T11: Reason for Moving: This turbine has been moved to improve separation distance to T10 in the prevailing wind direction.

Figure 2.12k
Infrastructure Design Review
- Turbine 11

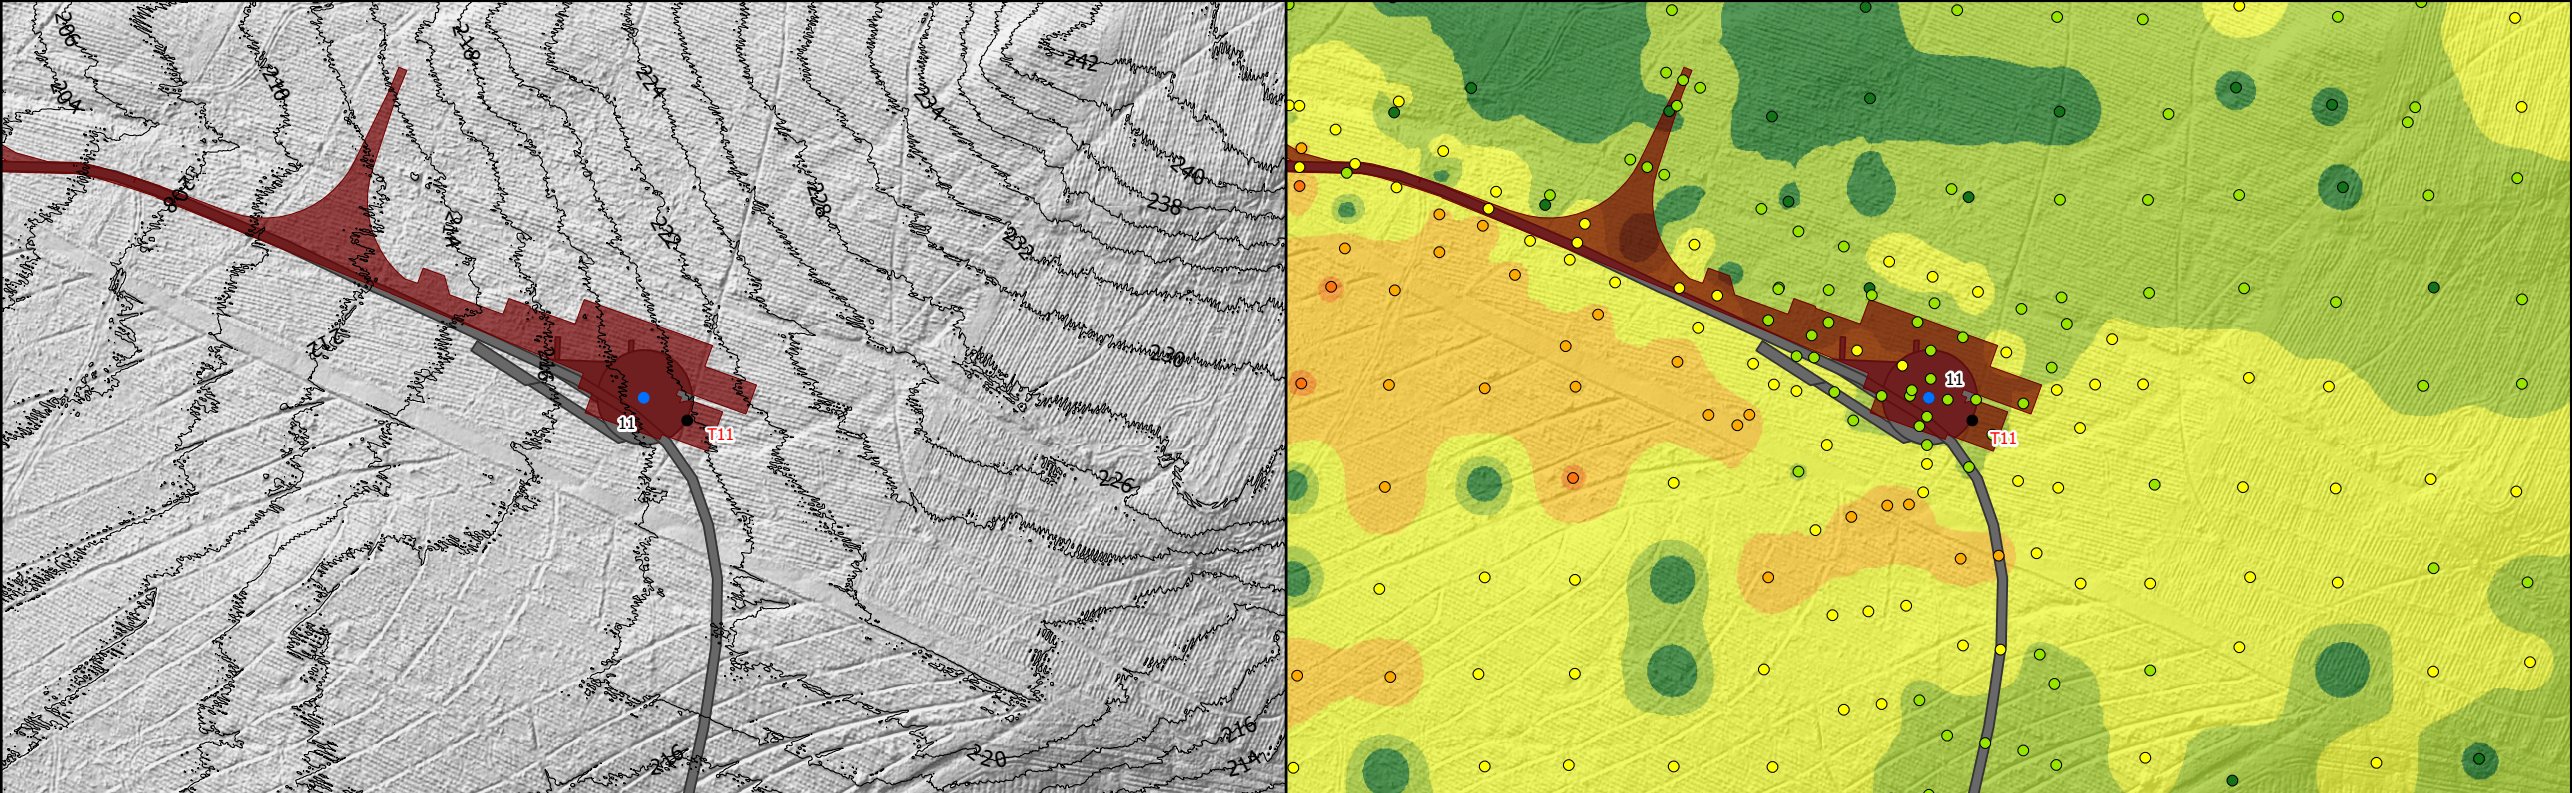
Engineering: The orientation and position of the turbine remains very similar between the consented and proposed location. Approximately 550m of track has been removed that used to link T11 and T12. This has been replaced with one turning head that sits between T10 and T11.

Geology Impacts: The infrastructure has been positioned to have a similar impact to the peat to that of the consented layout. The newly proposed turning head has been positioned so that it sits in an area of shallow peat.

Ecology Impacts: The turbine and infrastructure is located in an area that was commercial coniferous forest. The trees have now been felled. Landowner (FLS) has begun peat restoration in this area.

Hydrology Impacts: The main hardstand is positioned away from any water buffers. The loaded turning head is located next to a 50m water course buffer to the north west. Micrositing of this feature during construction will be restricted in this direction to maintain the buffer.
